REZONING & SUBDIVISION STAFF REPORT Date: November 2, 2006

<u>DEVELOPMENT NAME</u> Krewe of Marry Mates

AREA OF PROPERTY 4.8± acres

SITE PLAN

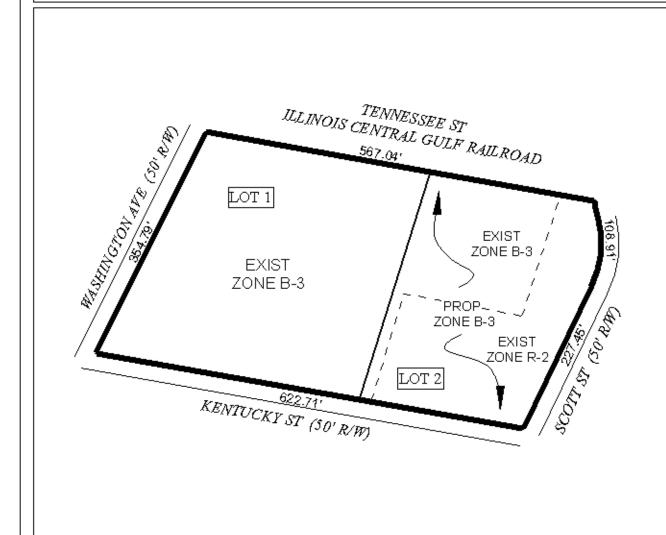
<u>COMMENTS</u> Show limits of AE flood zone on plat. Show minimum finished floor elevation on each lot. Must comply with all storm water and flood control ordinances. Any work performed in the right of way will require a right of way permit.

Preservation status is to be given to the 44" Live Oak Tree located on the South side of Lot 1. Any work on or under this tree is to be permitted and coordinated with Urban Forestry; removal to be permitted only in the case of disease or impending danger.

The site has frontage on three minor streets, which provide 50 feet of right-of-way each. Dedication of a 25-foot curb radius would also be required at the intersections of Washington Avenue and Kentucky Street; and Scott Street and Kentucky Street.

RECOMMENDATION Subdivision The plat meets the minimum requirements of the Subdivision Regulations and is recommended for Tentative Approval, subject to the following conditions: 1) the dedication of a 25-foot curb radius at the intersections of Washington Avenue and Kentucky Street; and Scott Street and Kentucky Street, with the size, design and location to be approved by Traffic Engineering; 2) the depiction of the 25-foot minimum building setback lines; 3) the placement of a note on the final plat stating that the site be limited to a single curb cut to Washington Avenue and Kentucky Street, with the size, design and location to be approved by Traffic Engineering; 4) the placement of a note on the final plat denying access to Scott Street; and 5) the provision of a buffer where the site adjoins residential property, in compliance with Section IV.D.1 of the Zoning Ordinance.
